CITY OF ALBUQUERQUE

Re: Drainage Control Ordinance and NPDES CGP Violations for Cement Pollution – The Boulders Subdivision

Large cement pollution 2 lots north of 9615 Big Rock Dr.

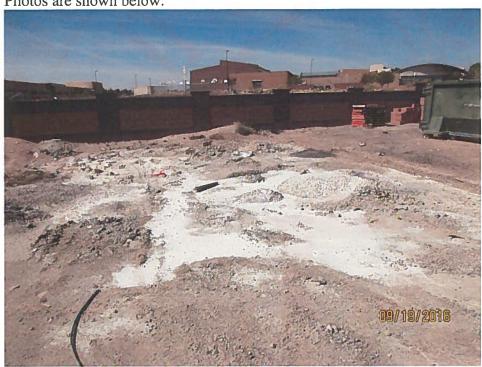
During the site inspection September 19th, 2016, three instances of cement pollution were observed; the large one was 2 lots north of 9615 Big Rock Dr. and the others were observed at 6000 Jagged Peak Rd.

- 1. Remove instances of cement pollution and discard appropriately.
- 2. Provide acceptable concrete and stucco wash-out area(s).
